**OFF-SITE INTERIM MEASURE WORK PLAN
AND RESPONSE TO COMMENTS**

**Franklin Power Products, Inc. / Amphenol Corporation
Administrative Order on Consent, Docket #R8H-5-99-002
EPA ID # IND 044 587 848
980 Hurricane Road
Franklin, Indiana 46131**

Date: June 18, 2019

**IWM Consulting Group, LLC
7428 Rockville Road
Indianapolis, IN 46214
Phone No. (317) 347-1111
Fax No. (317) 347-9326**

FIGURE 1
 STUDY
 AREA MAP

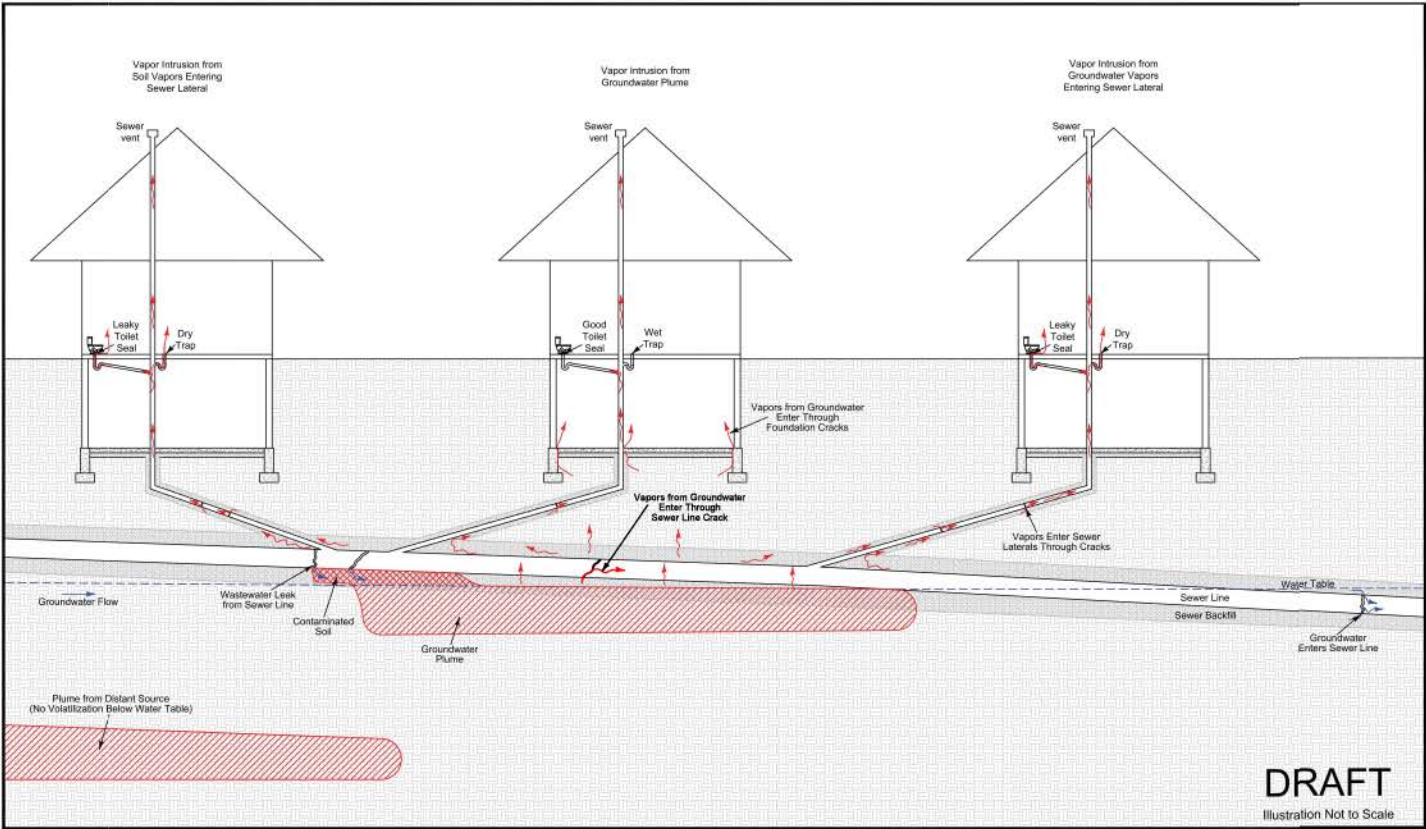
USEPA Minor Comment 17: *“Figure 1. Study Area Boundary*

The figure includes the extended study area boundary to the south where additional manholes were sampled as part of the sewer vapor investigation. In the next phase design, include the area to the west and south where additional groundwater sampling was completed.”

IWM Consulting Response: The Study Area Boundary has been updated on **Figure 1** to depict areas where off-site groundwater sampling has been conducted.
